CITY OF NAPOLEON - BUILDING DEPARTMENT
255 West Riverview Avenue, Napoleon, Ohio 43545 - 419-592-4010

RESIDENTIAL PLAN CORRECTION SHEET

ADDENDUM TO Permit No. 01286
Owner MIKE MCKIBBELL
Contractor HECK'S CONSTRUCTION
Location 955 MELODY LAKE

955 MELODY LN DE

SITE PLAN FOR

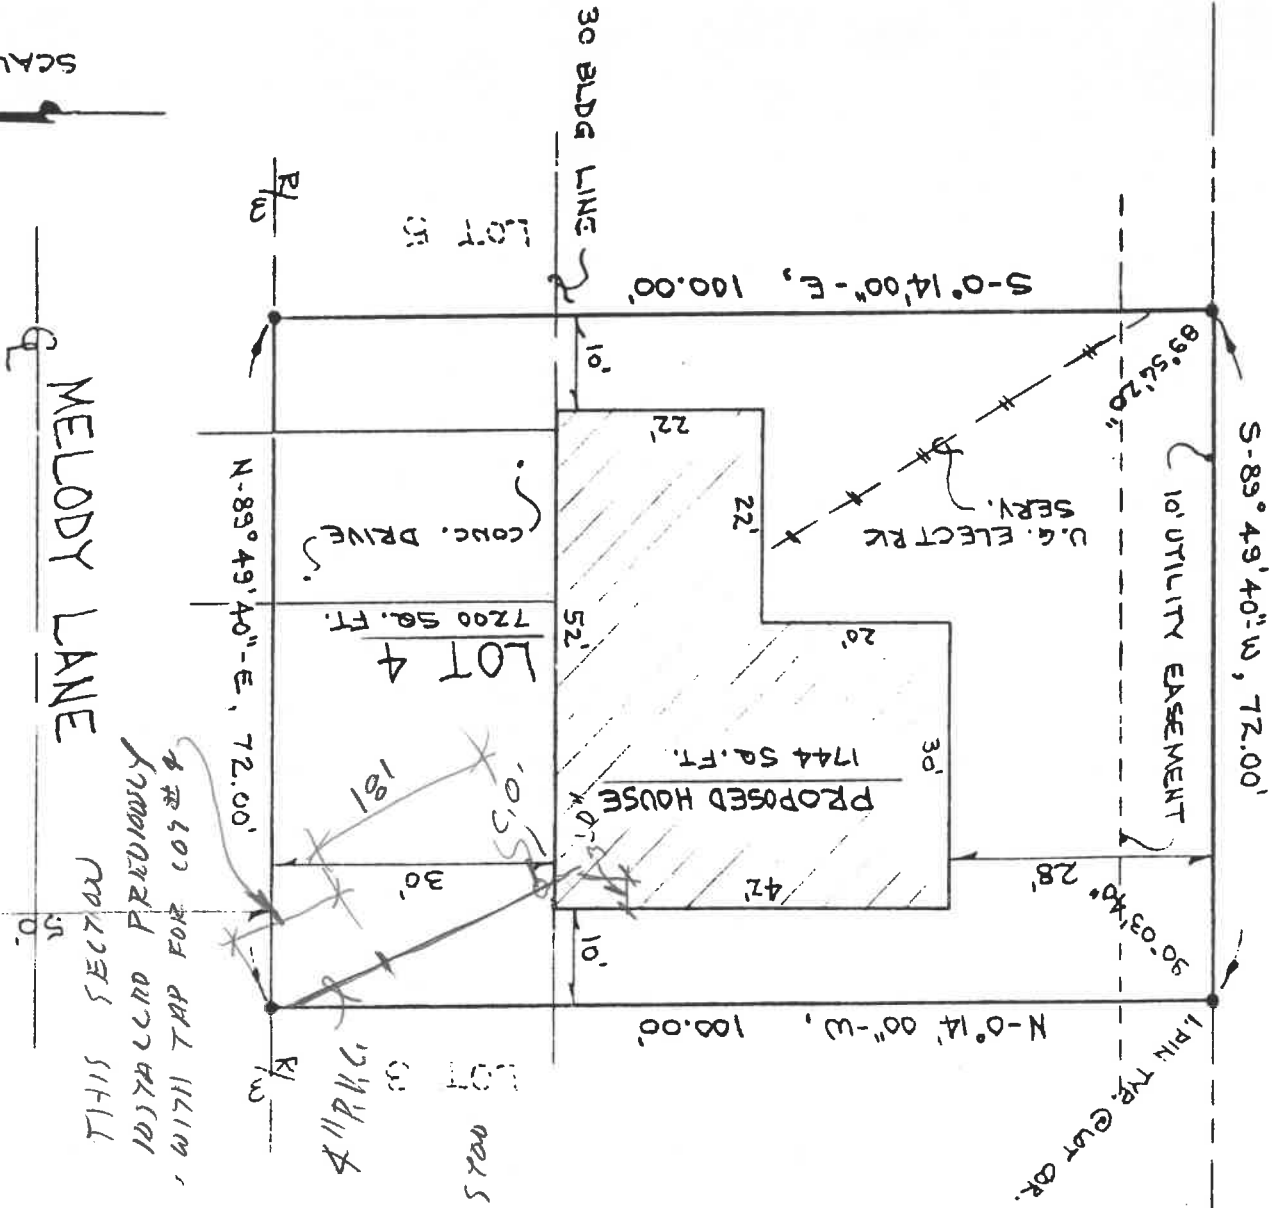
NOTE: STONE BELOW AND AROUND PIPE

GREEN SEWER PIPE CONNECTION TO SCH 40 PVC WITH RUBBER & SS HOSE CLAMP!

THIS SECTION PREVIOUSLY WOULD BE PREVIOUSLY WITH TAP FOR GAS & WATER
